**REGULAR MEETING
OF THE VINEYARD PLANNING COMMISSION,
Vineyard Town Hall, 240 East Gammon Road, Vineyard, Utah
Wednesday, January 21st, 2015 at 7:00 p.m.**

SUBJECT: Development Plan and Site Plan Approval
for 255 Mill Road Apartments

SUBJECT: Development Plan and Site Plan Approval
for Lakeside Apartments

— LANDSCAPE BERM, 3' MIN. HEIGHT
(SEE LANDSCAPING DETAIL)

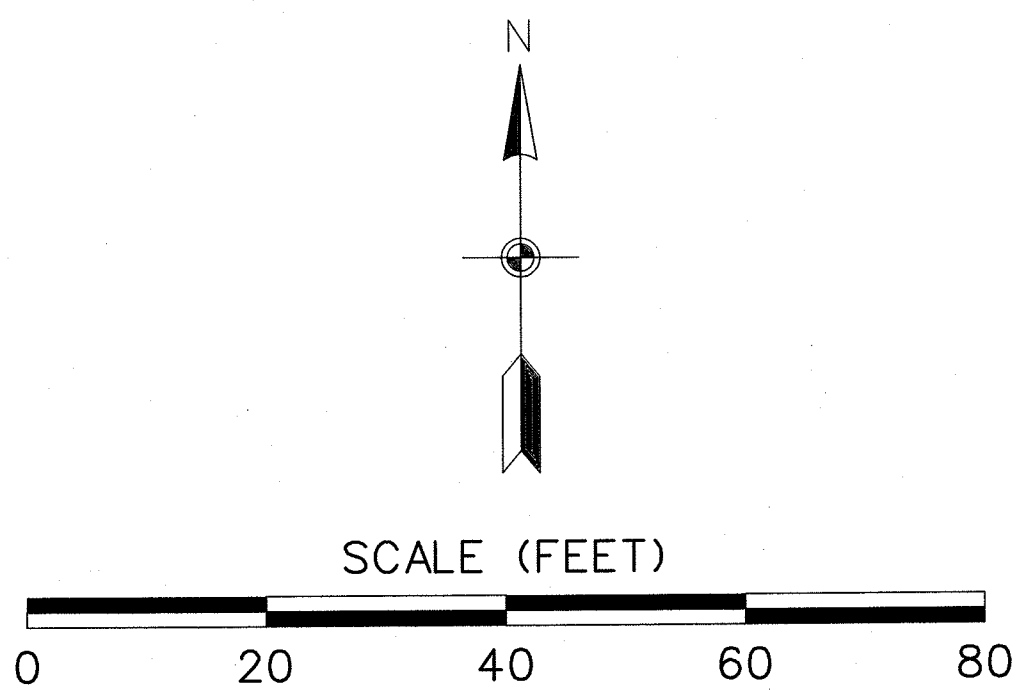
7. The site plan shows 908 parking spaces are provided. 905 parking spaces are required. A three foot high planted landscape berm is provided along Mill Road to screen the parking. Staff believes the height of the soil should be raised to three feet.

7. All parking canopies shall include a full fascia located at the edge of the canopy.
8. The height of the soil on the berm shall be raised to three feet.

A LANDSCAPE PLAN

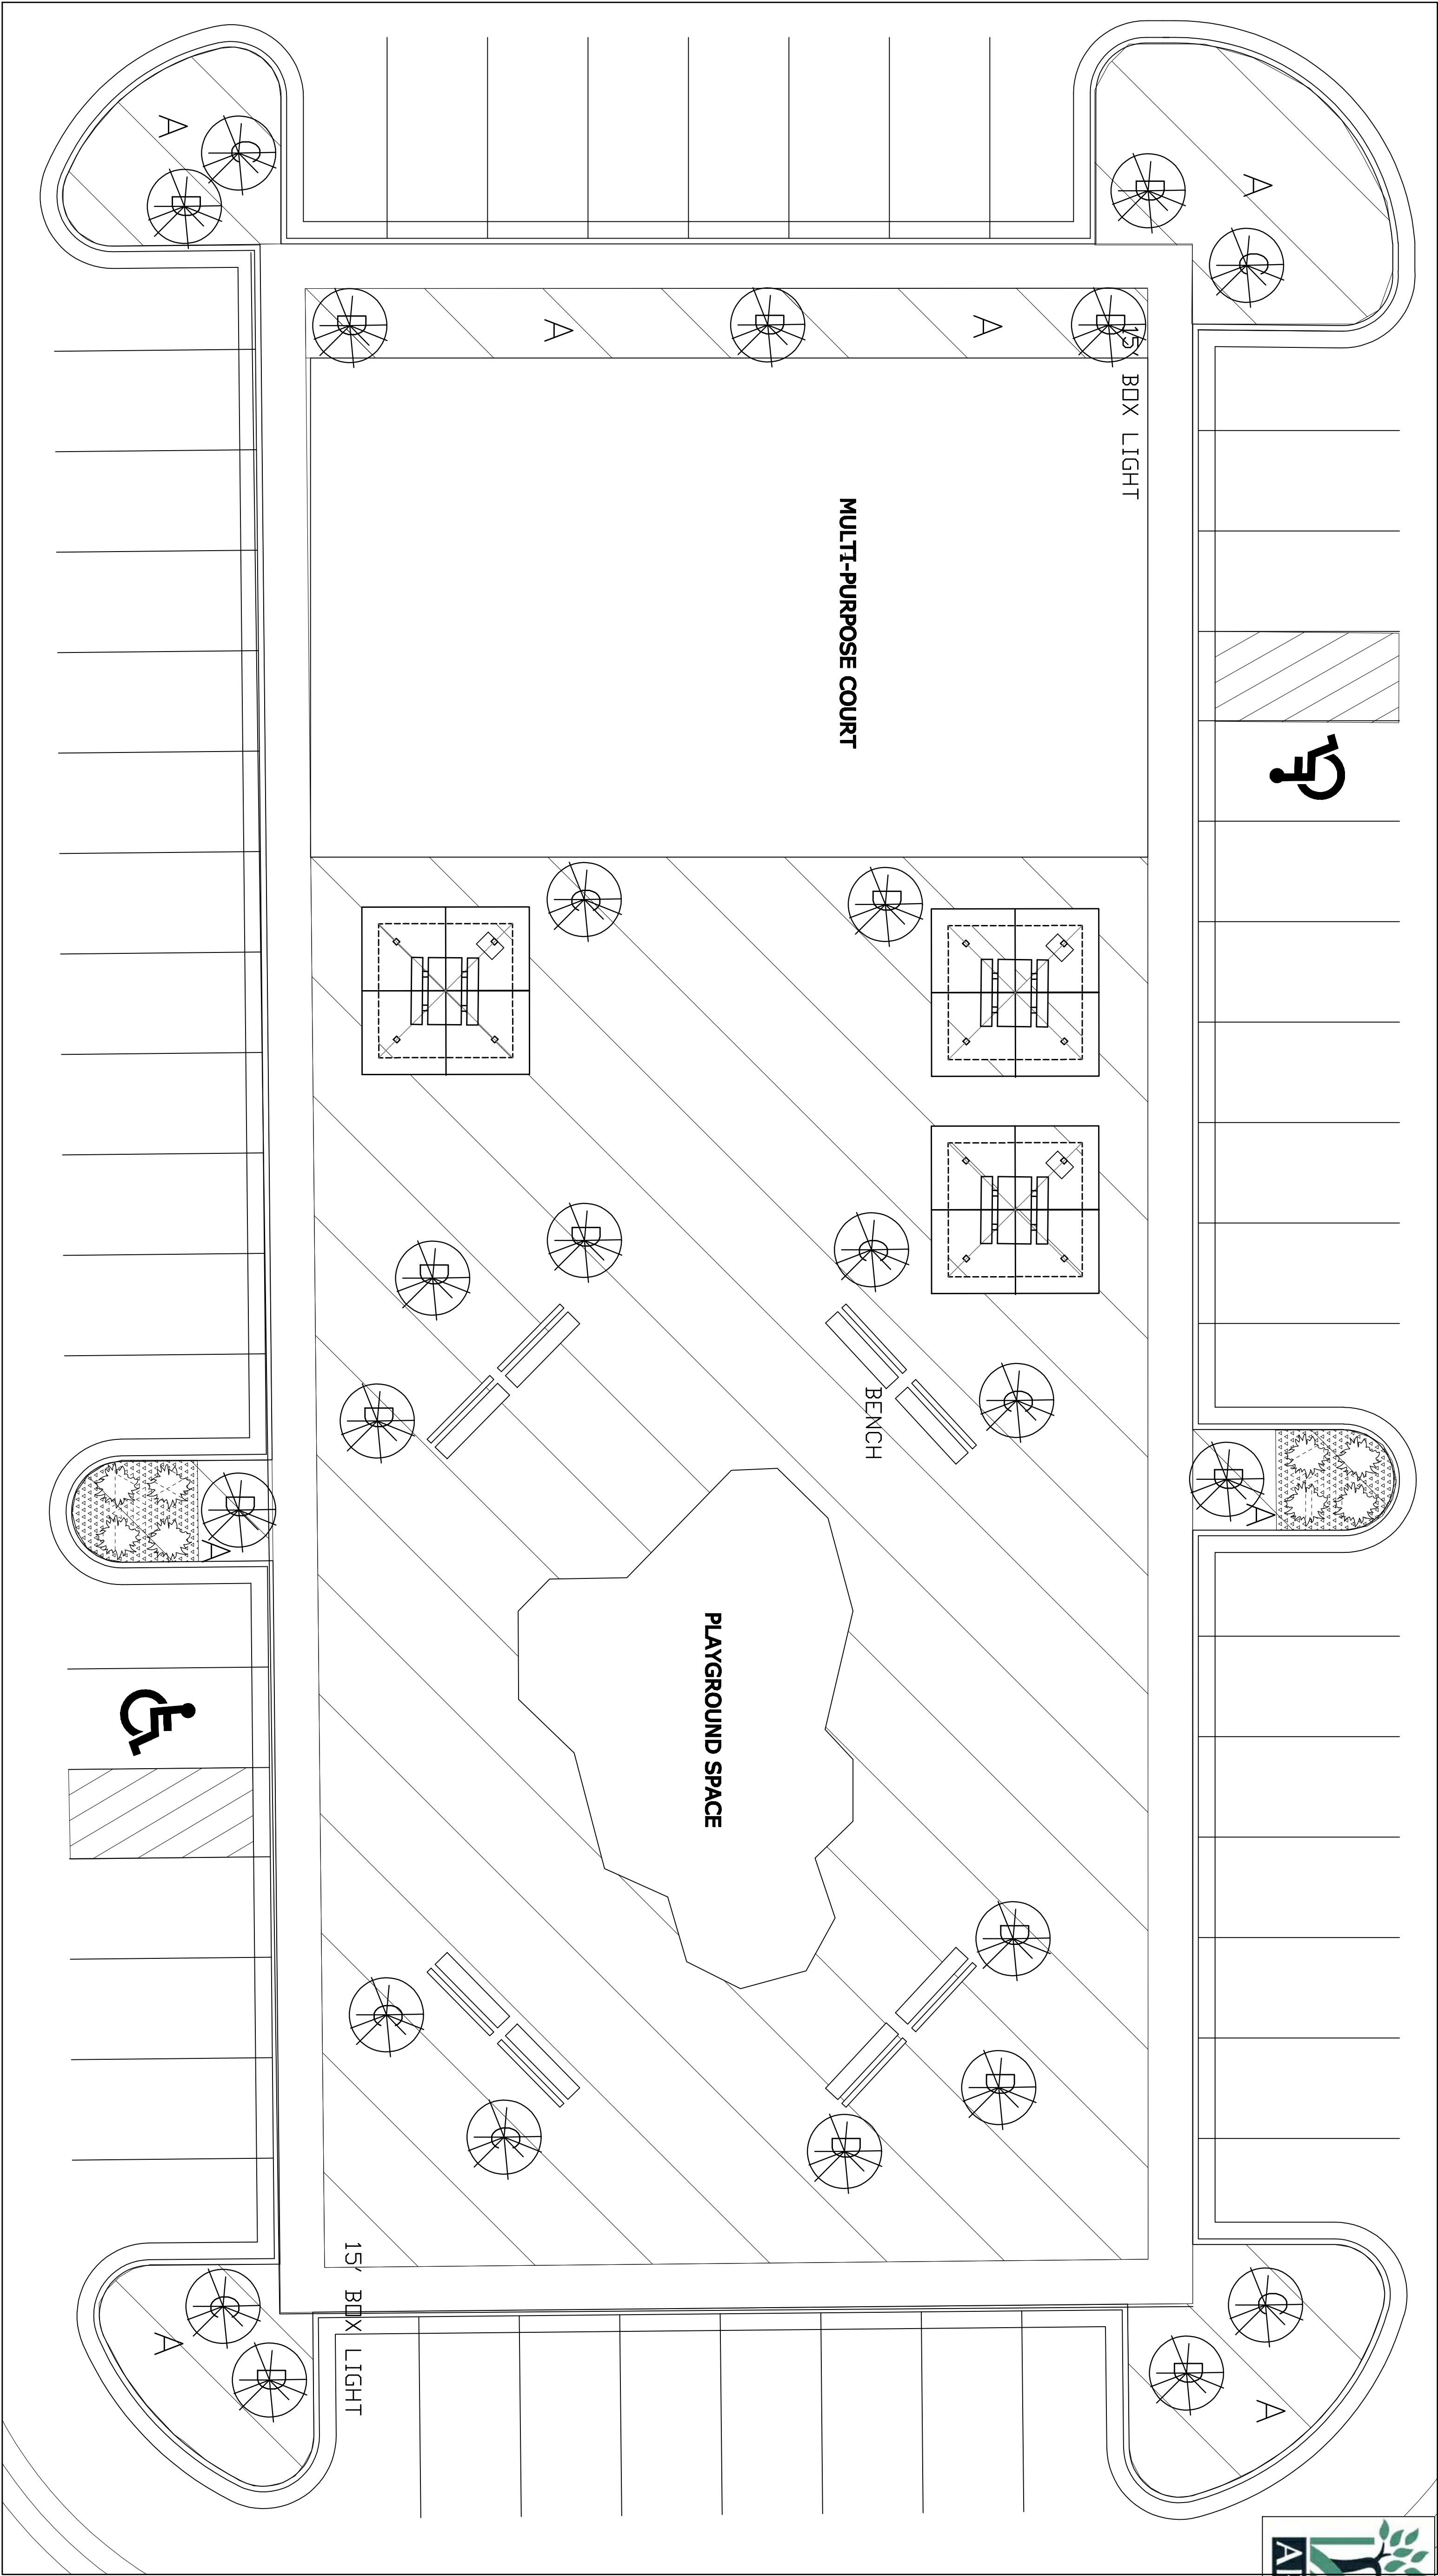
5. Two drainage pipes and a Central Utah Water Conservancy District water line will be located within an easement adjacent to the rail road tracks.
6. Approximately 6.06 acres (33.4%) of the site is landscaped. 2.68 acres (15%) of the site is recreational amenities. Recreation amenities include pool, playground, and open turf areas.

5. The final landscape plans shall be reviewed and approved prior to issuance of a building permit.
6. All building and free standing lighting shall be fully shielded and include cut-off lenses. All light levels shall not exceed one foot candle at the property line. The maximum height of the freestanding lightings is 16 feet.
